WORK CHANGE DIRECTIVE NO. 1

<b>PROJECT:</b>	<b><u>Horizon City Municipal Facilities Phase I</u></b>	<b>DATE OF ISSUANCE:</b> February 27, 2025
<b>OWNER:</b>	TOWN OF HORIZON CITY 14999 Darrington Rd. El Paso, Texas 79928	<b>EFFECTIVE DATE:</b> March 11, 2025
<b>CONTRACTOR:</b>	<b><u>Dantex General Contractors</u></b> <b><u>4727 Osborne</u></b> El Paso, Texas 79922	<b>OWNER'S BID NO.</b> CSP 23-038 Project No. 22.513D
		<b>ARCHITECT:</b> <b><u>Eugenio Mesta</u></b> (AOR) <b><u>Rafael Renovato</u></b> (CM & RPR)
<b>CONTRACT FOR:</b>	<b><u>New Municipal Facility for the City of Horizon</u></b>	<b>ARCHITECTS PROJECT NO.</b> 20201600

RE :  
**Horizon Municipal Facilities Phase 1  
Proposed Change Order #05, Additional Concrete Work**

# PROPOSED CHANGE ORDER REQUEST NO. 05

DWG NUMBER:  
AB1 OF 3

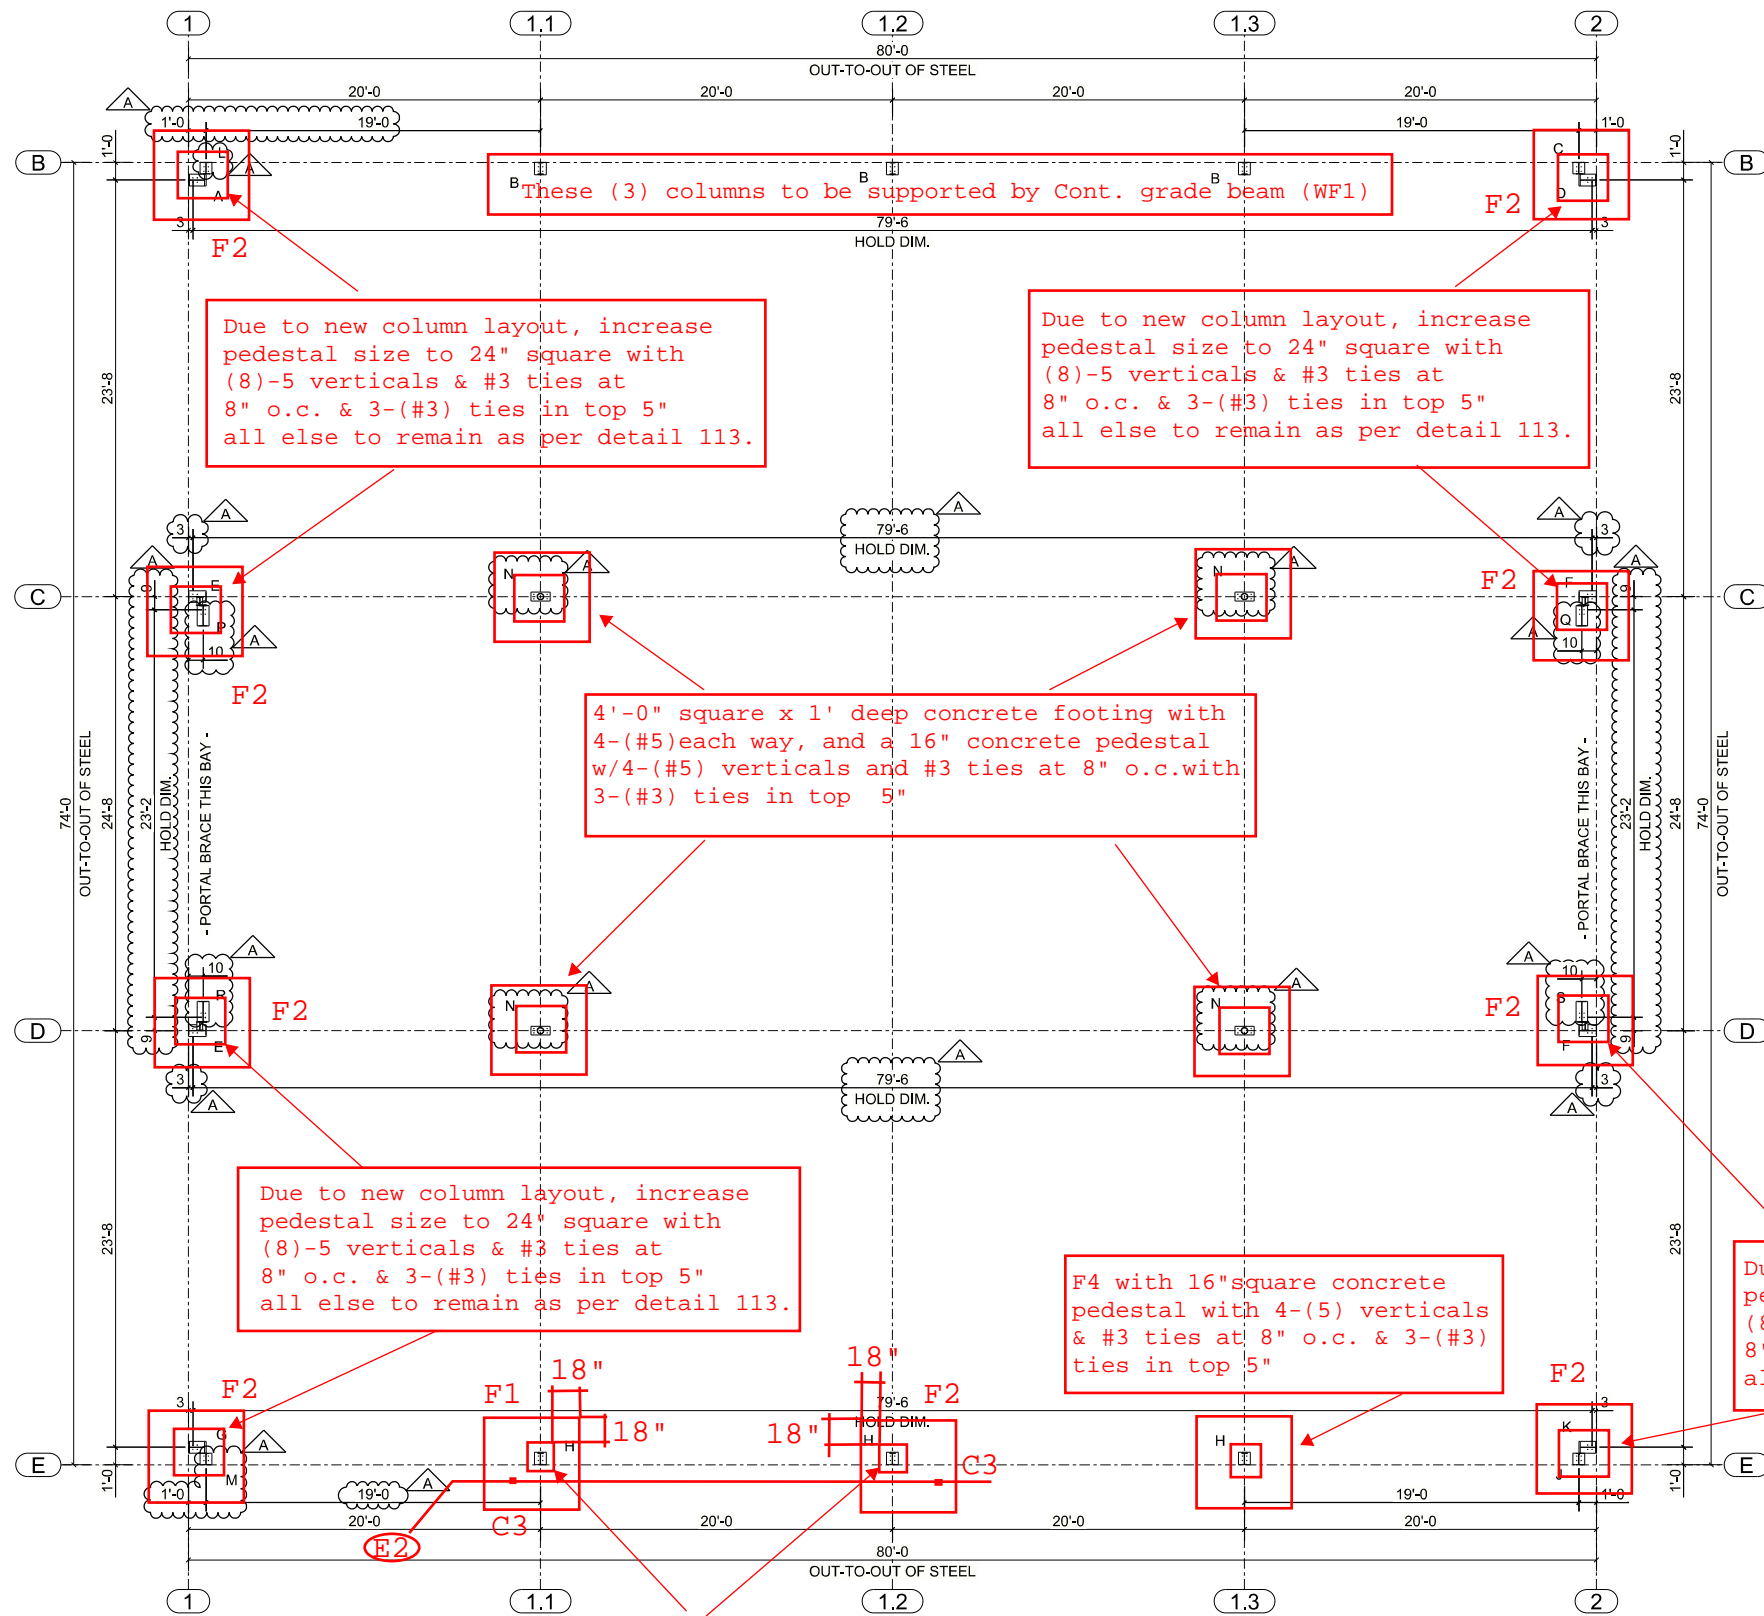
Due to new column layout, increase pedestal size to 24" square with (8)-5 verticals & #3 ties at 8" o.c. & 3-(#3) ties in top 5" all else to remain as per detail 113.

Due to new column layout, increase pedestal size to 24" square with (8)-5 verticals & #3 ties at 8" o.c. & 3-(#3) ties in top 5" all else to remain as per detail 113.

4'-0" square x 1' deep concrete footing with 4-(#5) each way, and a 16" concrete pedestal w/4-(#5) verticals and #3 ties at 8" o.c. with 3-(#3) ties in top 5"

Due to new column layout, increase pedestal size to 24" square with (8)-5 verticals & #3 ties at 8" o.c. & 3-(#3) ties in top 5" all else to remain as per detail 113.

F4 with 16" square concrete pedestal with 4-(5) verticals & #3 ties at 8" o.c. & 3-(#3) ties in top 5"

Due to new column layout, increase pedestal size to 24" square with (8)-5 verticals & #3 ties at 8" o.c. & 3-(#3) ties in top 5" all else to remain as per detail 113.

16" square concrete pedestal with 4-(#5) verticals & #3 ties at 8" o.c. & 3-(#3) ties in top 5"

G.C. To coordinate column locations with architectural drawings. Footings/pilasters have been provided.  
JTA Engineering
